**COMMUNITY DEVELOPMENT DEPARTMENT
PLANNING DIVISION
STAFF REPORT**

RE: Names Residence: Siding and Windows (PL-DR-22-0026)
Public Meeting Date: June 9, 2022

Names Residence: Siding & Windows | PL-DR-22-0026

Re: Alternate Design Review Narrative: Front Façade: Windows and Trim
Names Residence
3404 Ross Ave, Gig Harbor, WA

Proposed elevation with stone planter box added

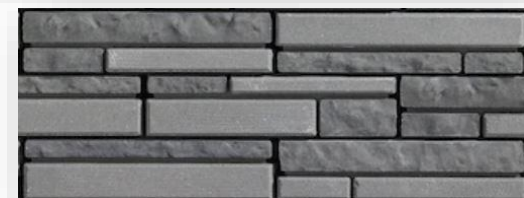
- **17.99.530.B – Conform to solid/void ratio requirements**

Existing installed windows = 34 sf/167 sf wall plane:
20.4% of front wall facade

Existing installed windows and trim = 48 sf/167 sf wall plane
28.7% of front wall facade

Proposed planter box + window and trim = 67 sf/167 sf wall plane
40.1% of front wall facade

Proposed planter to be constructed using 4x16 Belgard® Bluff Wall or similar product

Photos of existing installed windows

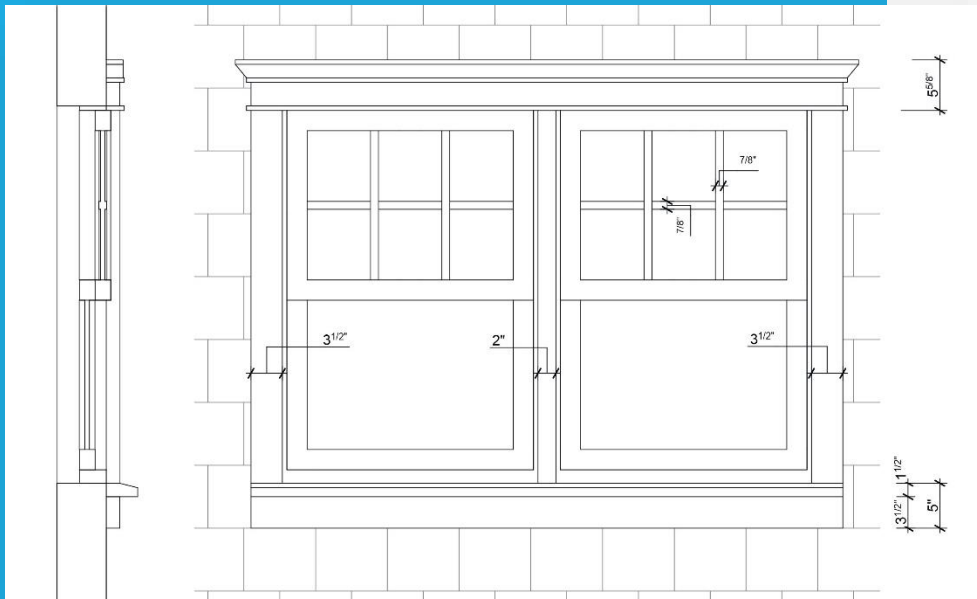
- Installed windows have (6) panes in the top sash, and none in the bottom sash
- Window muntins beveled, contoured and are less than 2" wide

17.99.530.C – USE WINDOW MUNTINS REPRESENTATIVE OF GIG HARBOR'S HISTORIC STRUCTURES

Rendered image of proposed facade

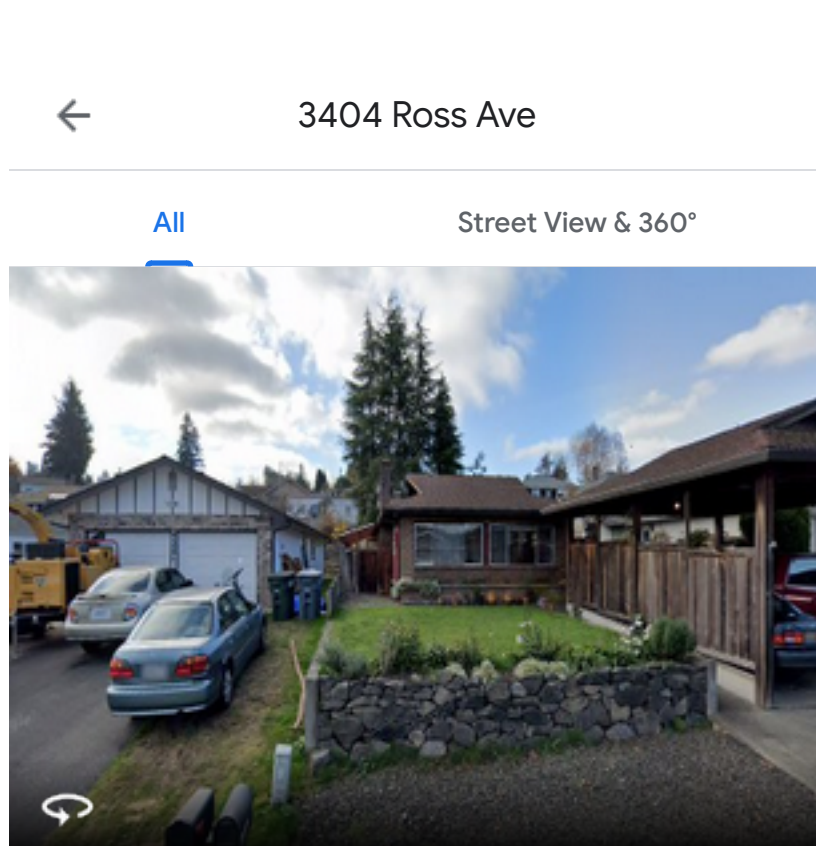
Summary of Superior Design items that meet the intent of the Design Manual for DRB's recommended approval

17.99.530.B - Conform to Solid/Void Ratio Requirements

17.99.530.C - Use window muntins representative of Gig Harbor's historic structures

17.99.530.K - Wrap windows in a traditional manner
